EARTHWORK QUALITY CONTROL OVERVIEW
AND AS-BUILT DRAWINGS
CONSTRUCTION OF STAGE I
TAILINGS IMPOUNDMENT AND DAM
SHOOTARING CANYON URANIUM PROJECT
Garfield County, Utah

PLATEAU RESOURCES LIMITED
772 Horizon Drive
Grand Junction, Colorado 81501

July 28, 1982

Figure 2

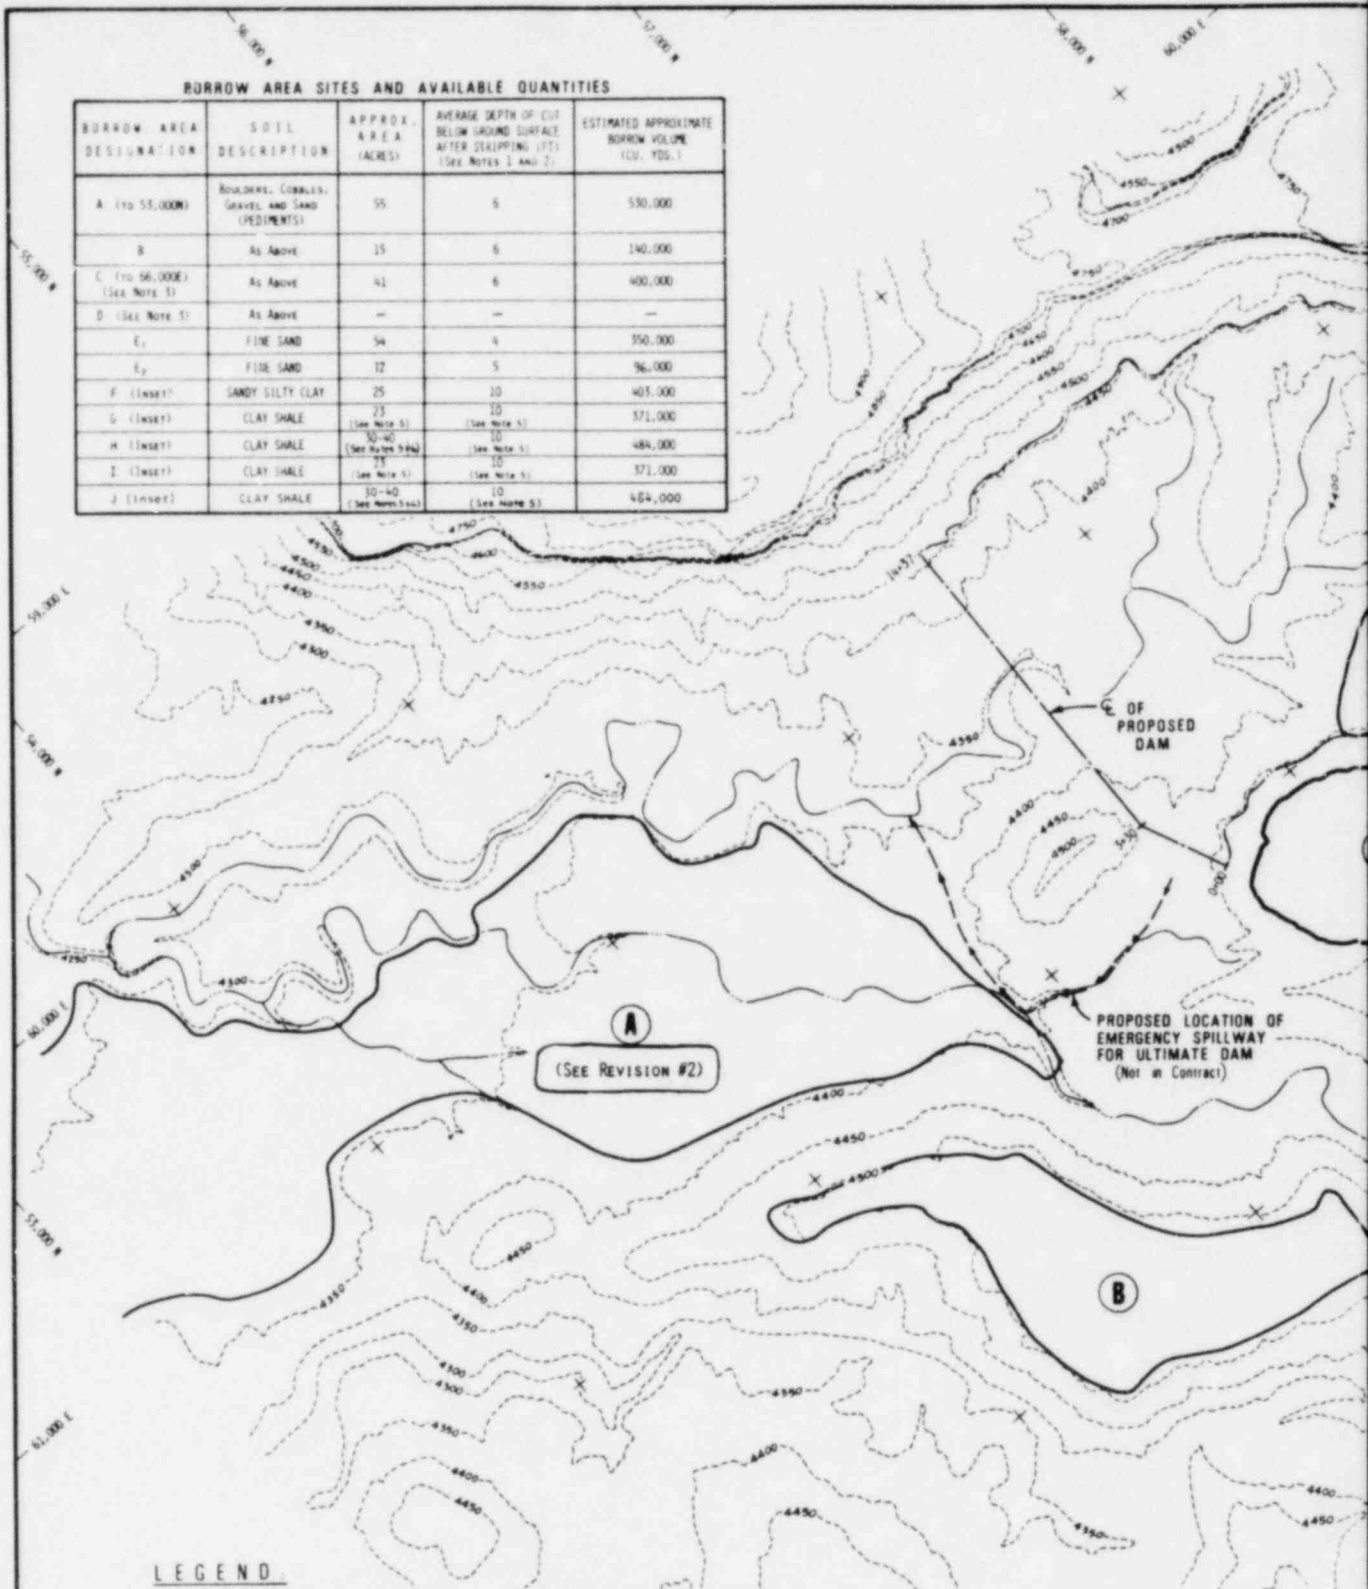
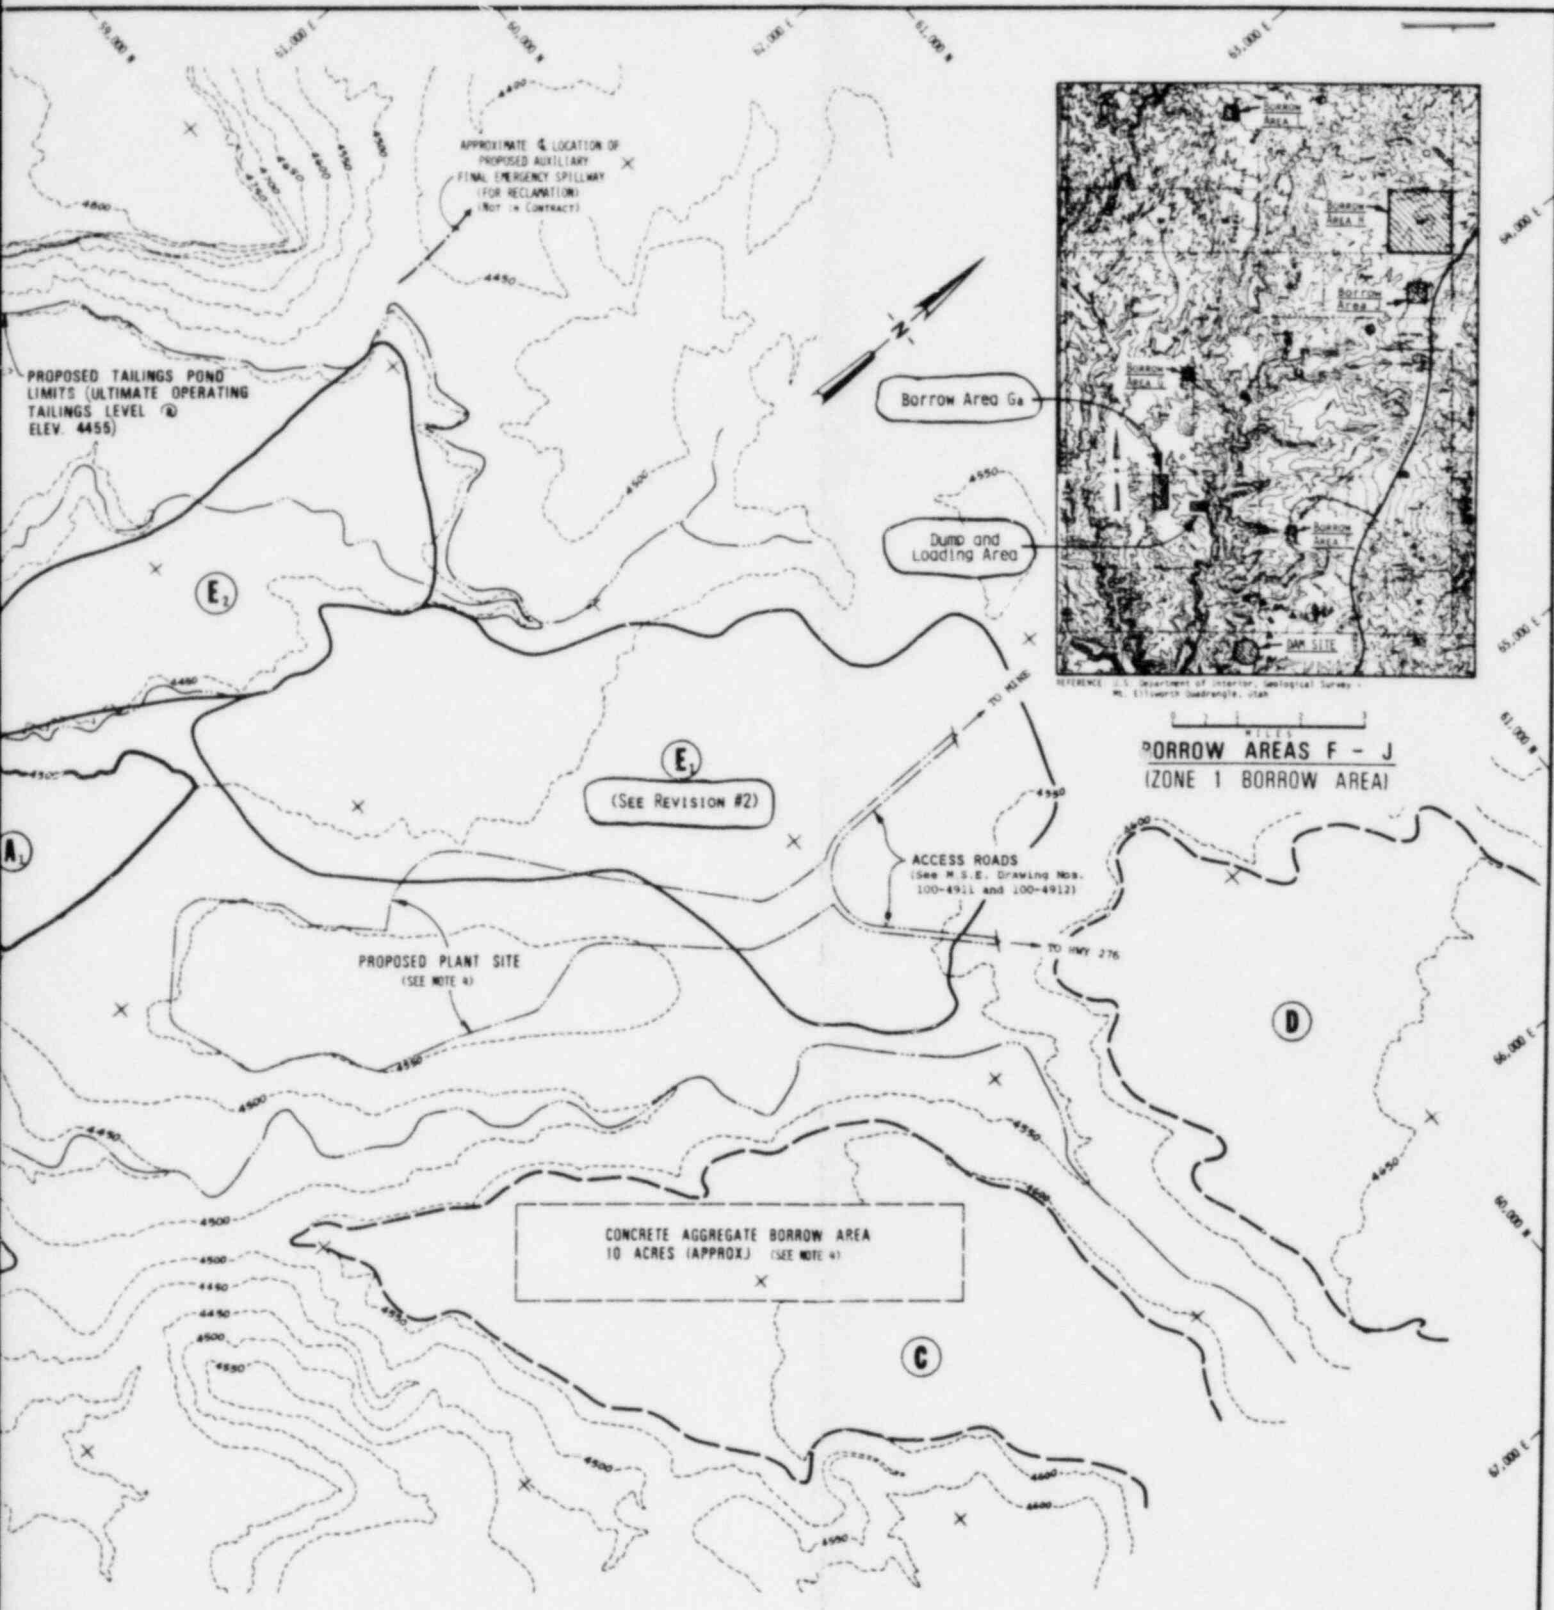
2	6-23-82	AS-BUILT Changes: Added Borrow Area (A ₂) to Site Map. Area (A ₂) was the actual source of Zone 1. Zone (1) was taken from Area (E ₁). Zone (2) primarily came from Area (A ₁).	BBG
1	1-12-81	Addition of BORROW AREA A ₁	D.A.P.
No.	DATE	REVISIONS	By
R.E. NO. 1933		APPROVED:	
DATE: 5-24-79		<i>Ronald B. Gordon</i>

Project No. 60255J
Woodward-Clyde Consultants
 Figure 3

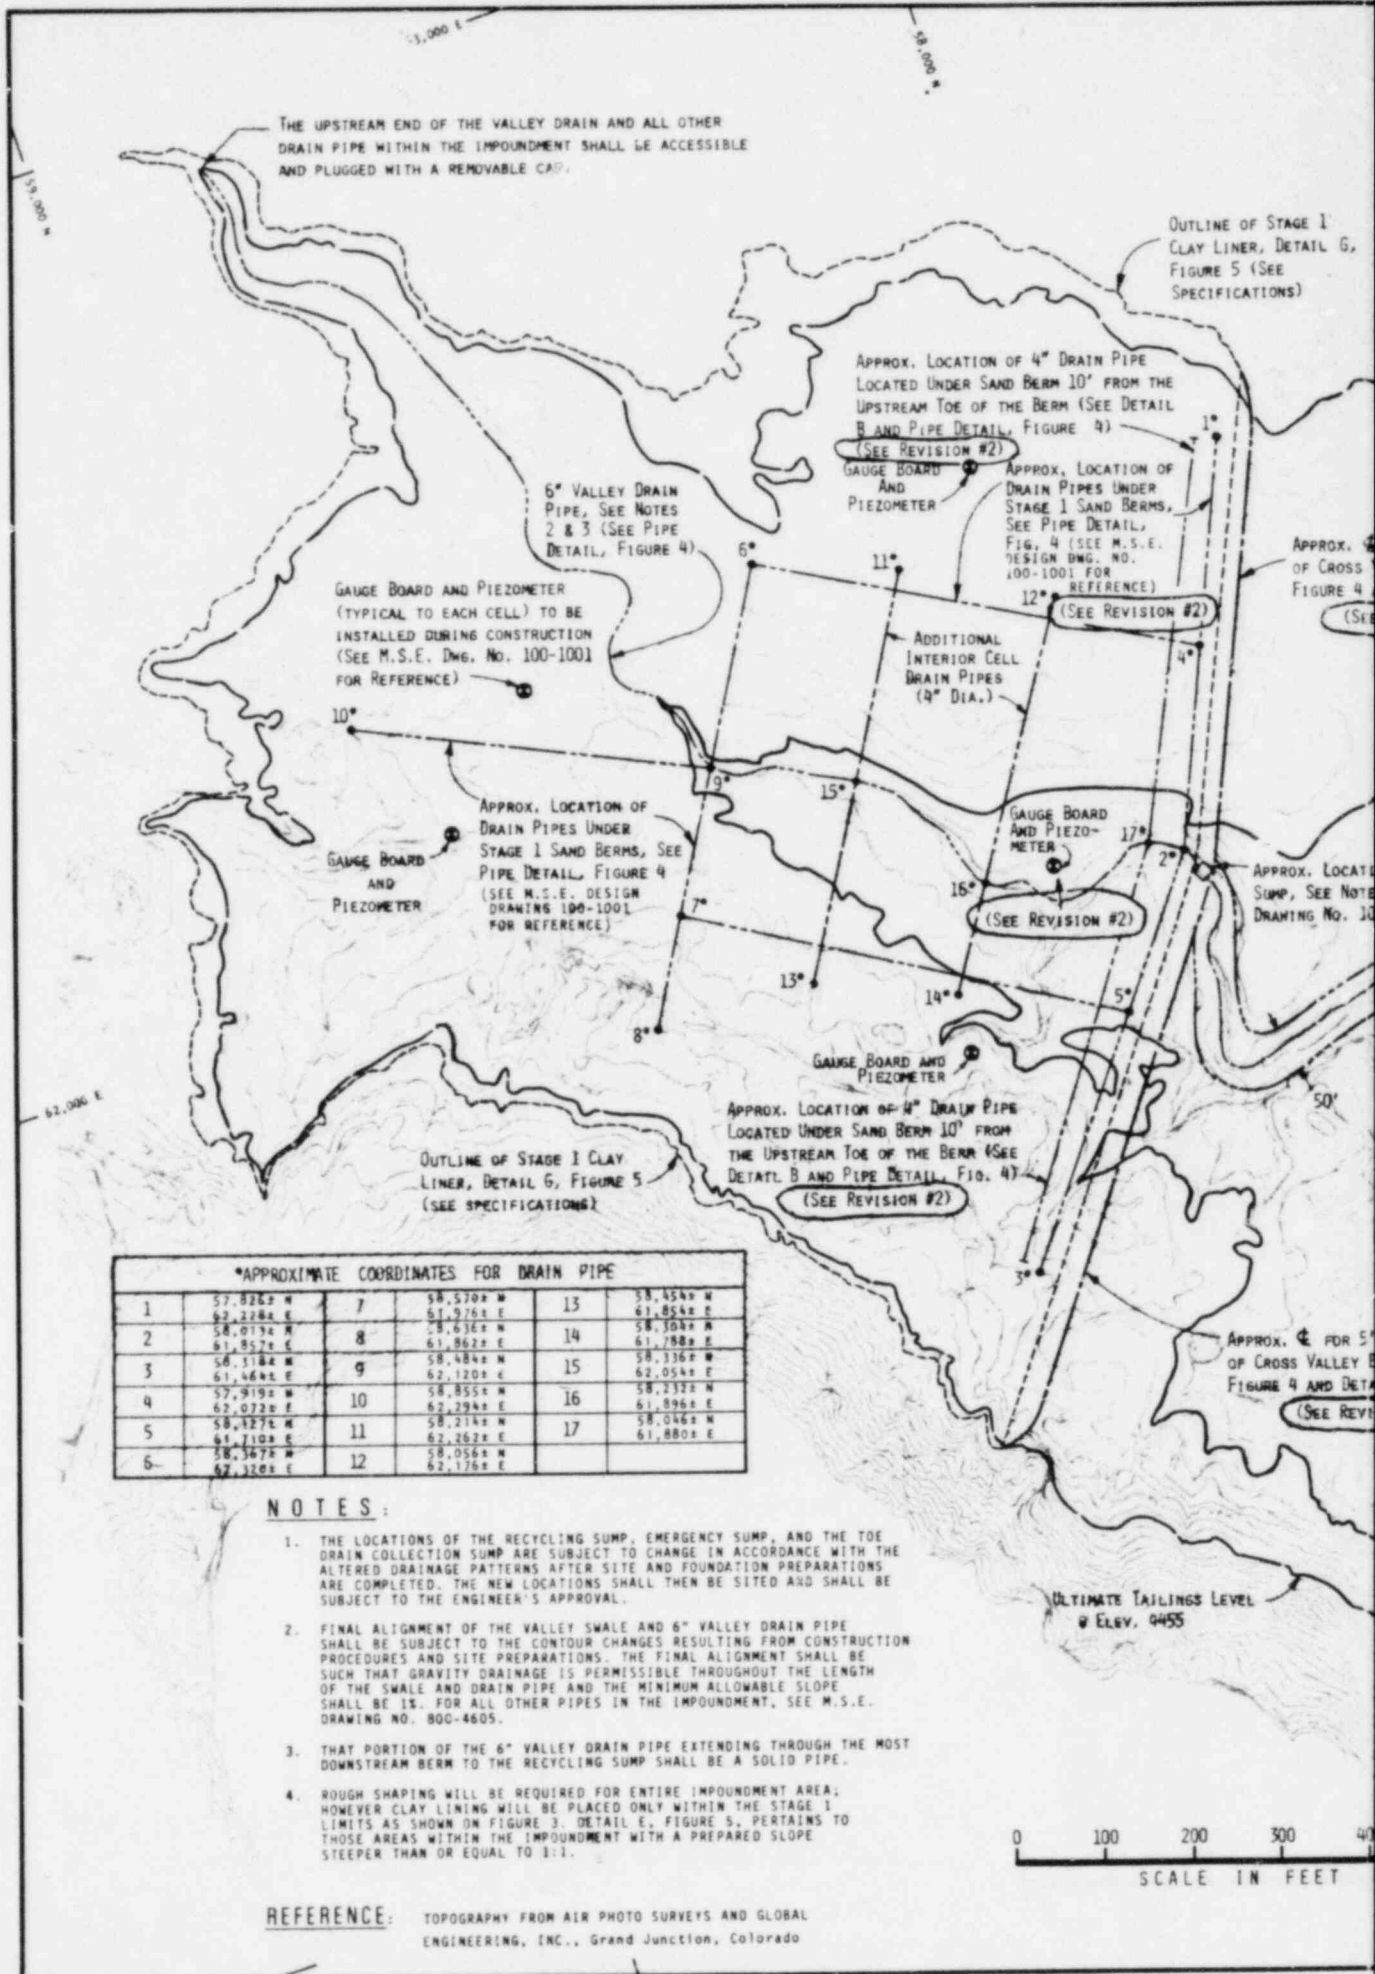
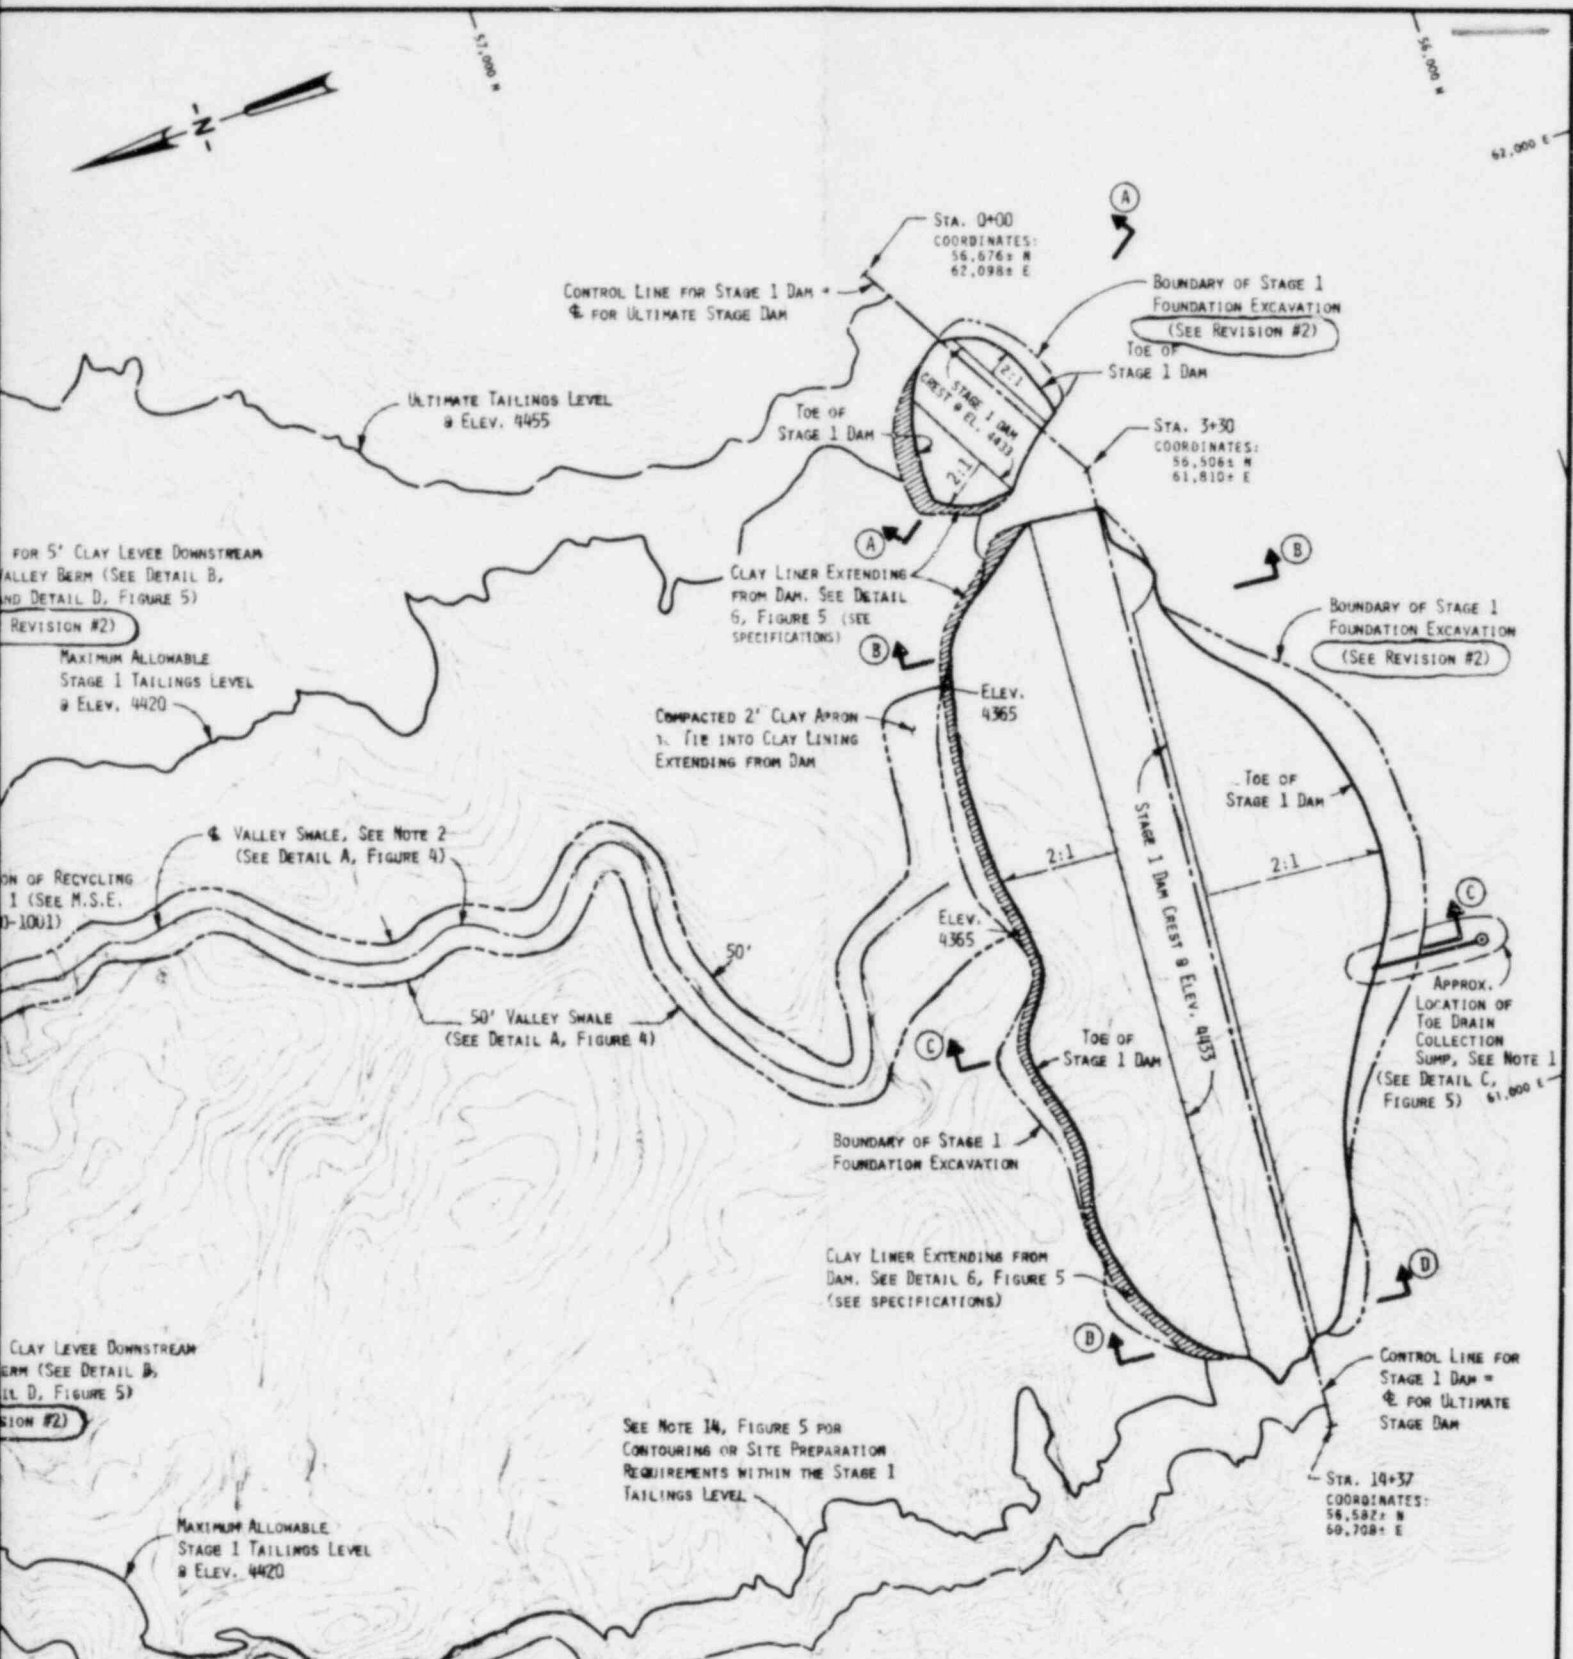
APPROX. LOCATION OF 4" DRAIN PIPE LOCATED UNDER SAND BERM 10' FROM THE UPSTREAM TOE OF THE BERM (SEE DETAIL B AND PIPE DETAIL, FIGURE 4) (SEE REVISION #2)

APPROX. LOCATION OF DRAIN PIPES UNDER STAGE I SAND BERMS, SEE PIPE DETAIL, FIG. 4 (SEE M.S.E. DESIGN DWG. NO. 100-1001 FOR REFERENCE) (SEE REVISION #2)

GAUGE BOARD AND PIEZOMETER (SEE REVISION #2)

2	6-23-82	AS-BUILT Changes are shown on this sheet or referenced to appropriate MSME Drawings. These include: Drawings-- II-1 (Dam Area Plan and Profile). II-2 (Impoundment Area Topo Map, Drain Pipes and Piezometers, Cross Valley Berm and Upper Impoundment, Zone 1 Finish Grade). II-5A, II-5B, II-5C (As-Built Profile, 4" and 6" Drain Pipe Impoundment Area). II-6 (Typical Section - Cross Valley Berm).	BBG
1	4-8-80	ADDED ADDITIONAL INTERIOR GULL DRAIN PIPES AND COORDINATES OF PIS. II - 17. CORRECTED NOTE 1.	BBG/DAP
NO.	DATE	REVISIONS	By
